# FY17 Vermont Better Roads Grant Application

Project Name: Cruickshank Road Stream Bank Stabilization

**Project Assessment:** Jct. Cruickshank Rd. & Bull Run Rd.

Re: Bank Armor Bull Run Brook for protection of Cruickshank Rd.

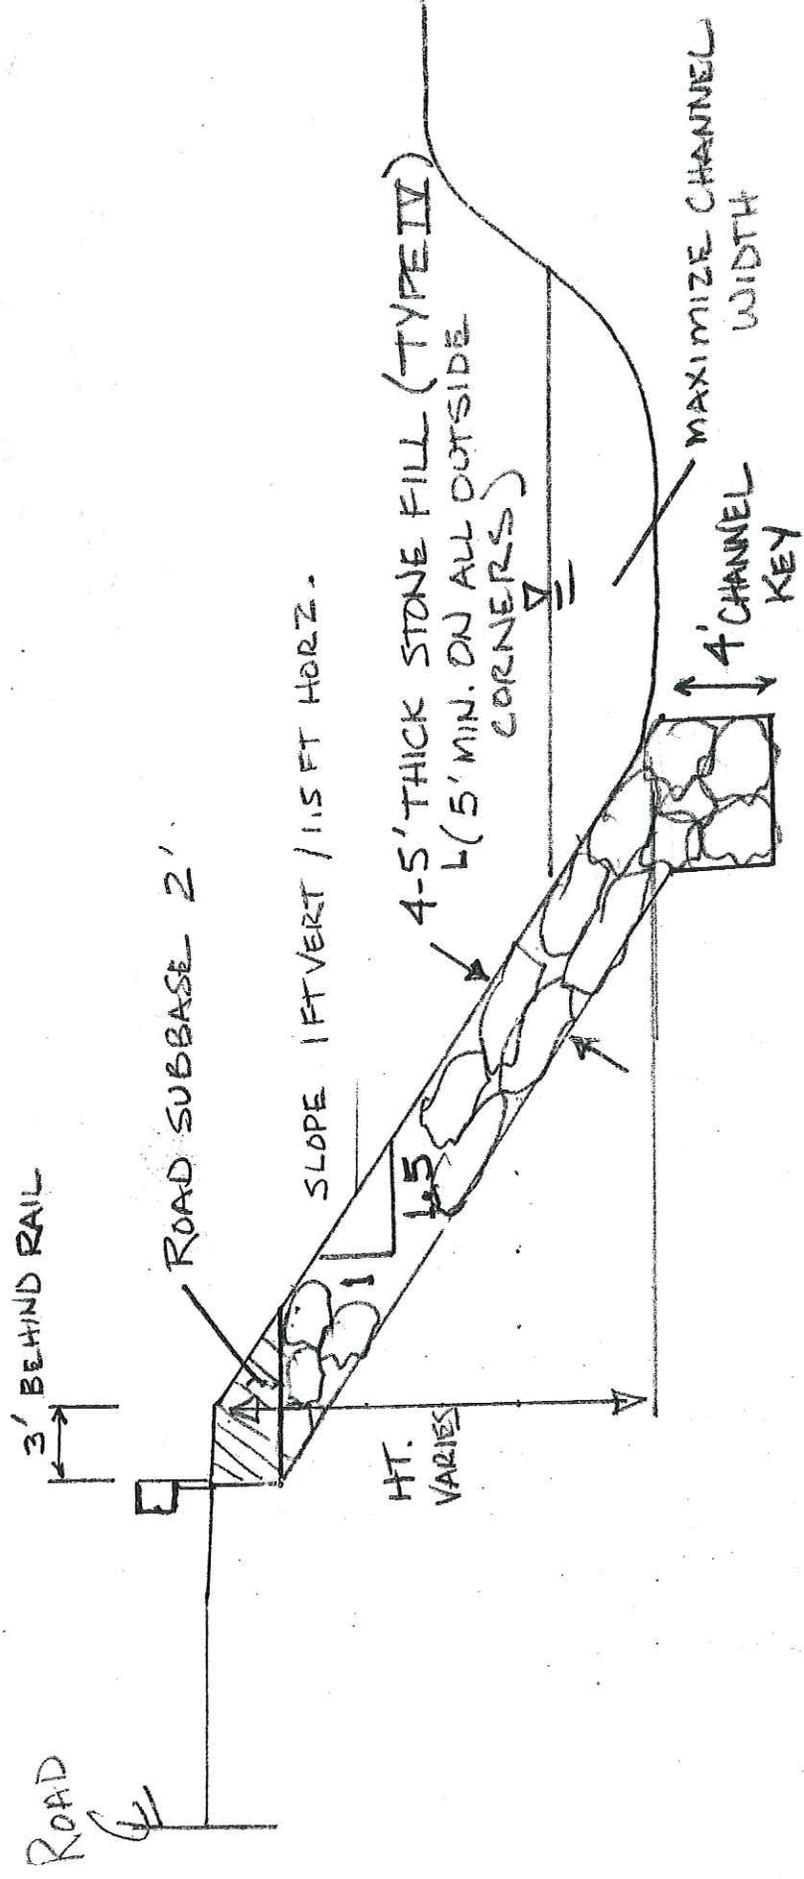
Thank you for taking the time to meet with me last Friday (01/22/2016) regarding the junction of Cruickshank Rd and Bull Run Rd in East Roxbury. At the time of our visit signs of erosion on the right bank of Bull Run Brook were evident. A section approximately 200' from the crossing of Bull Run Rd was recently armored to prevent further erosion into the shoulder of Cruickshank Rd. Downstream of this section more recent erosion was evident along an approximately 70' section, with clearing of some of trees taking place in 2013 after a large storm event to minimized local erosion points. In the present plan geometry of the stream it is expected that Bull Run Brook will migrate laterally toward Cruickshank Rd. This expected to destabilize the roadway and pose an increased risk to public safety at this location. Although there is not an immediate need for bank protection, given the history of stream movement at this location, it is expected to need work in the near future. Additionally, work conducted with the present channel geometry will result in less of an impact to the stream as encroachment into the developed channel will be minimized. If an application to appropriately repair the 70' section of eroding bank were submitted, it would be permissible under the State of Vermont's Stream Alteration General Permit. If you have any questions or comments regarding this letter please do not hesitate to contact me.
